PROJECT: Ferndale Terrace Project

City Project SW2016-01; TIB Project Number 8-2-985(011)-1

**ADDENDUM NO. 3**  
To the Contract Documents for:  
City of Ferndale, Washington  
FERNDALE TERRACE PROJECT  
City of Ferndale Project No. SW2016-01; TIB Project Number 8-2-985(011)-1

DATE <b>1/31/25</b>
' = 20'      v; 1" = 2'	SHEET <b>41</b> of 85

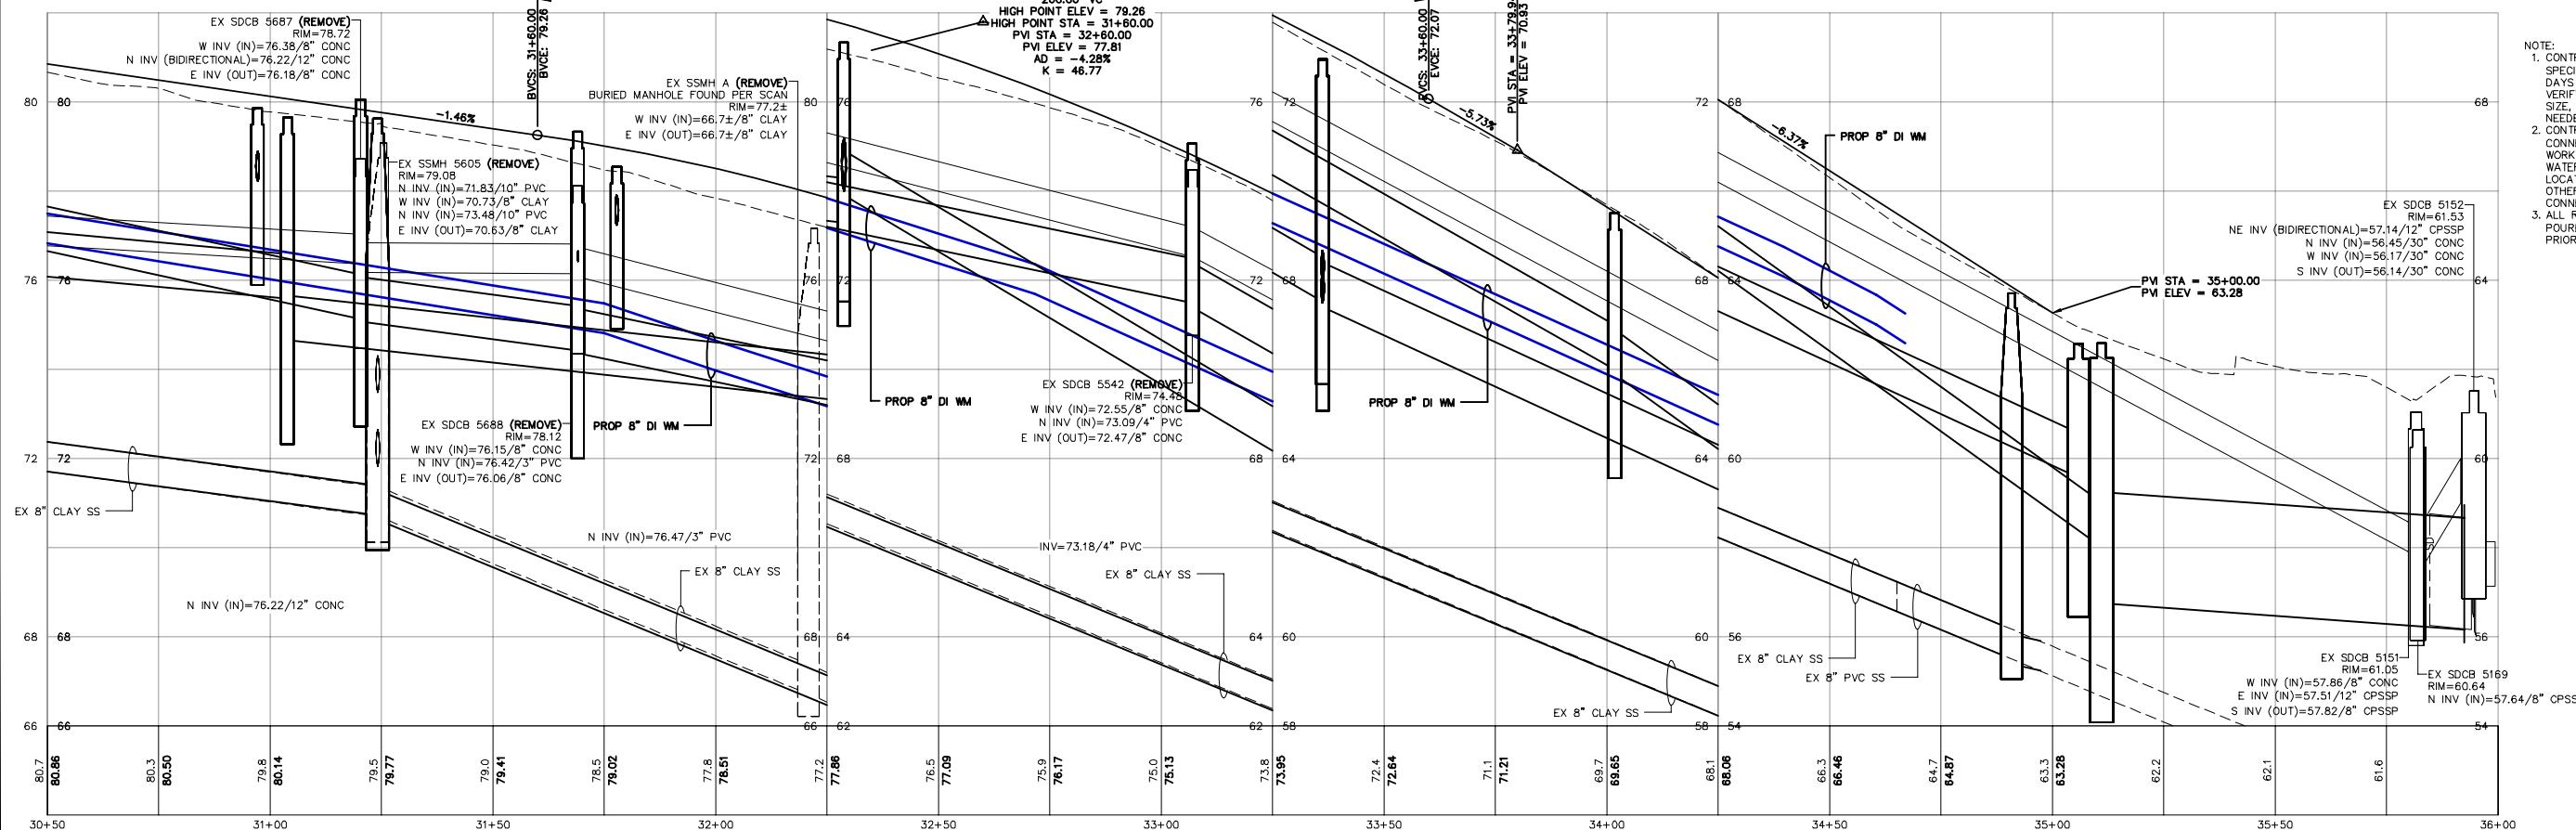
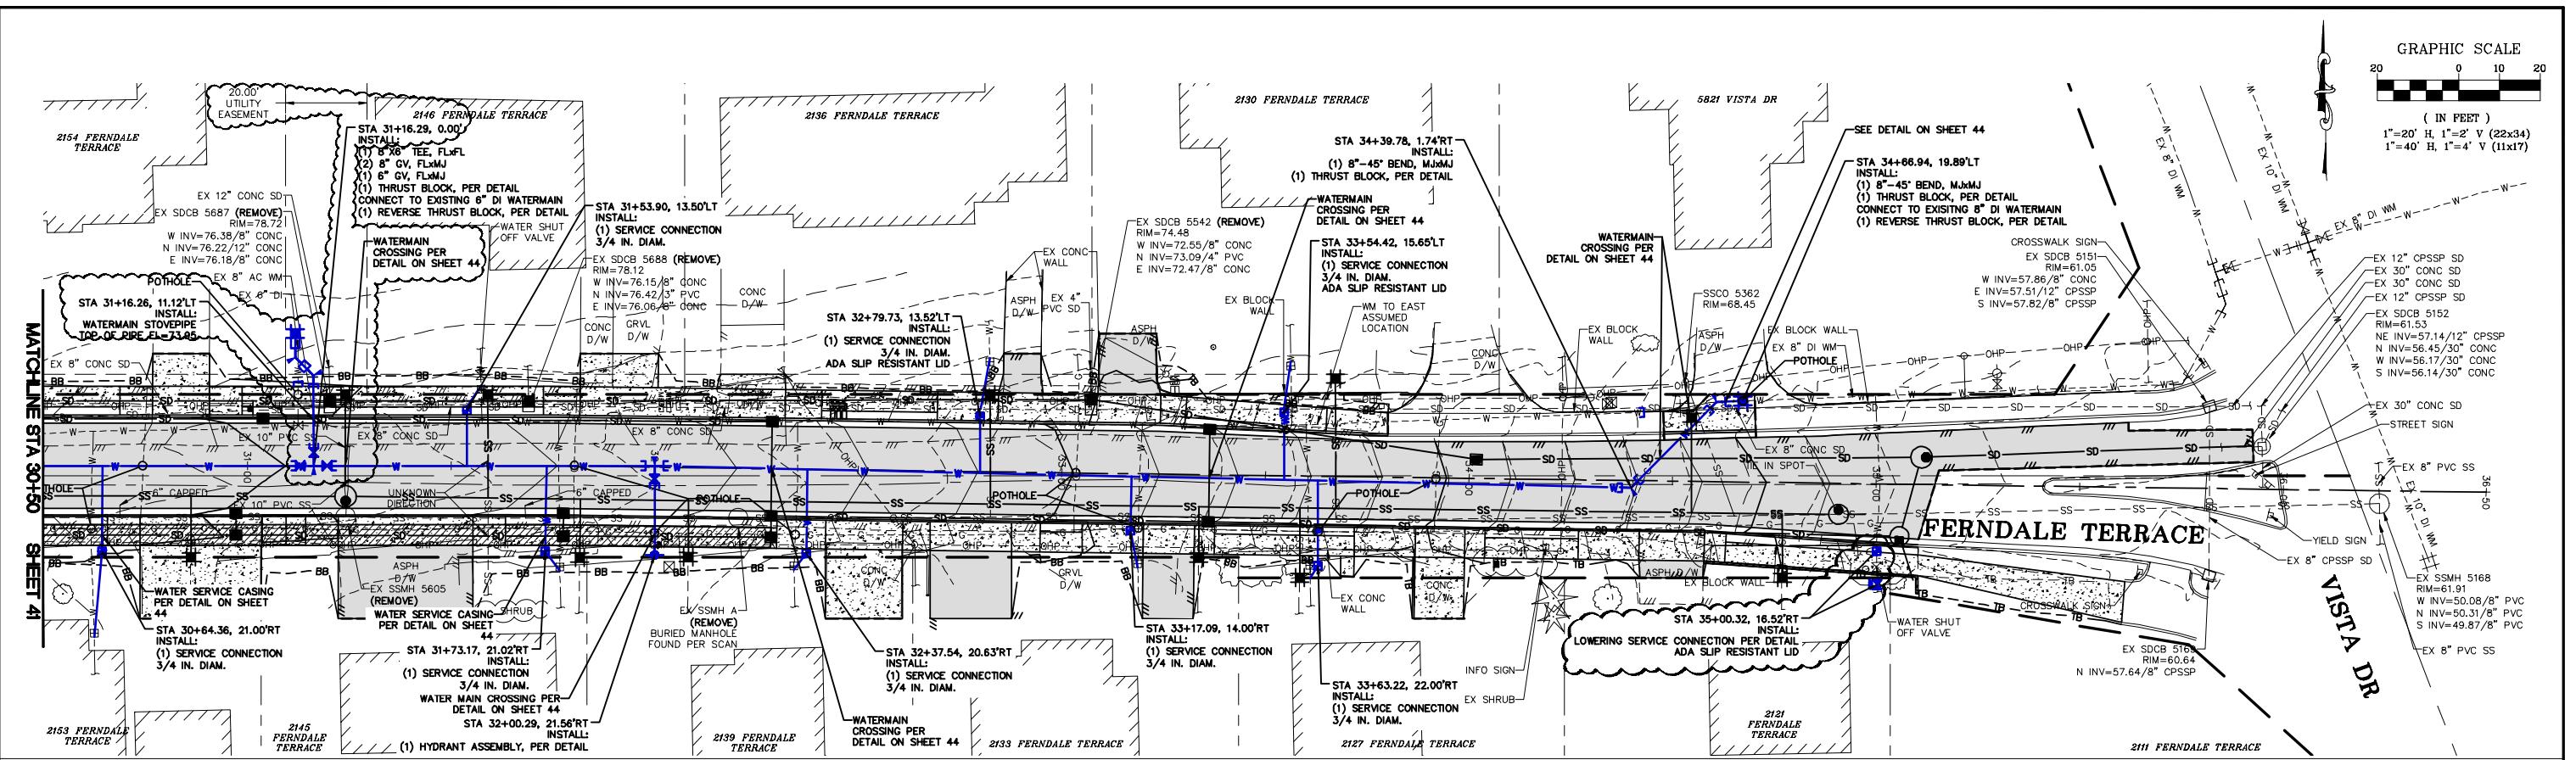
Sheet 41, watermain stovepipe and pothole callout added at STA 27+95.45, LT.

**LOWERING SERVICE CONNECTION**

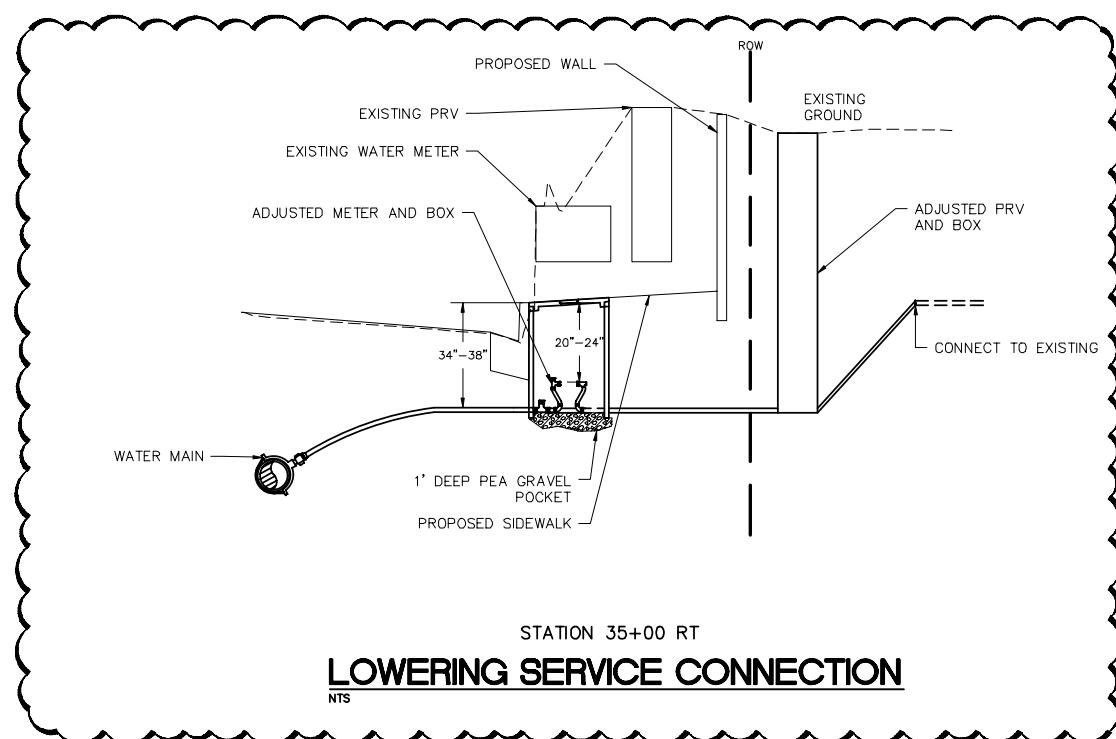
Sheet 44, added "Lowering Service Connection" detail.

Where the existing service connection is shown in the Plans for adjustments to conform to a new street alignment or grade or both, the service and the PRV shall be relocated without disturbing the location of the service lateral at the connection point. The meter box and meter setter shall be installed at the new elevation.
